## **Proposal for Supplement 3 to the 03 Series of Amendments to UN Regulation No. 100 (Electric power trained vehicles)**

### **Submitted by the expert from the International Association of the Body and Trailer Building Industry \***

**Marking of vehicles of category O under the scope of UN Regulation No. 100: ~~Use of wheel chocks~~**

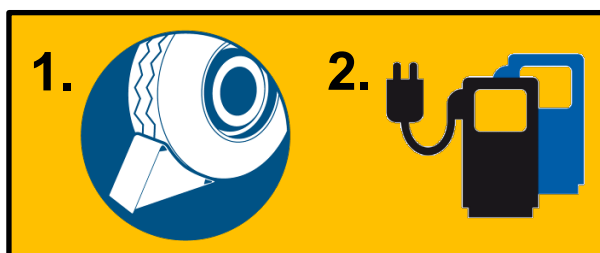
**In the case of vehicles of category O under the scope of UN Regulation No. 100, the vehicle shall be equipped with wheel chock(s) to prevent the vehicle movement during the charging from external power supply. ~~provide an audible warning if any vehicle movement is detected, and movement shall be impeded by the use of wheel chocks.~~ A visual instruction shall be made visible by a symbol shown in Figure 3 near the vehicle inlet.**

13. **Paragraph 5.3.3. and new figure 3:** In cases when the trailer REESS is charged externally ~~the trailer shall provide an audible warning if a trailer movement is detected.~~ **Furthermore** an instruction to use wheel chocks is to be placed on a label near the trailer inlet.

Figure 1  
Generic Description of Test Pulses

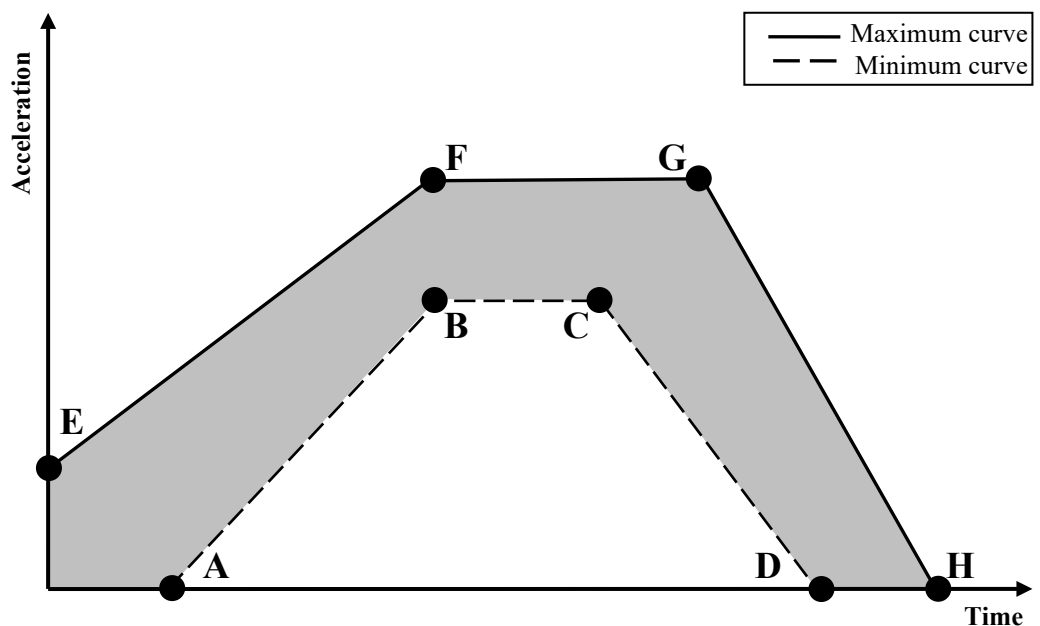
The Tested-Device shall be decelerated or accelerated in compliance with the acceleration corridors which are specified in Tables 1 to 43. The manufacturer shall decide whether the tests shall be conducted in either the positive or negative direction or both.

The test pulse shall be within the minimum and maximum value as specified in Tables 1 to 43. A higher shock level and /or longer duration as described in the maximum value in Tables 1 to 43 can be applied to the Tested-Device if recommended by the manufacturer.

15. **Annex 9C Mechanical shock Paragraphs 3.2.:** The resistance against mechanical shock focuses on pulses of crash tests or similar performance tests of vehicles of categories N1, N2, N3, M1, M2 and M3. Trailers are normally not in the scope of crash test regulations due to the absence of passengers. Therefore it is recommended to define basic performance pulses for trailers in relation to the category of the trailer. REESS on O1/O2 may be tested with the pulse as defined for N3. REESS for O3/O4 may be tested with a pulse related to requirements about the ADR ("Agreement concerning the International Carriage of Dangerous Goods by Road " – Transport of dangerous goods) UNECE.
-
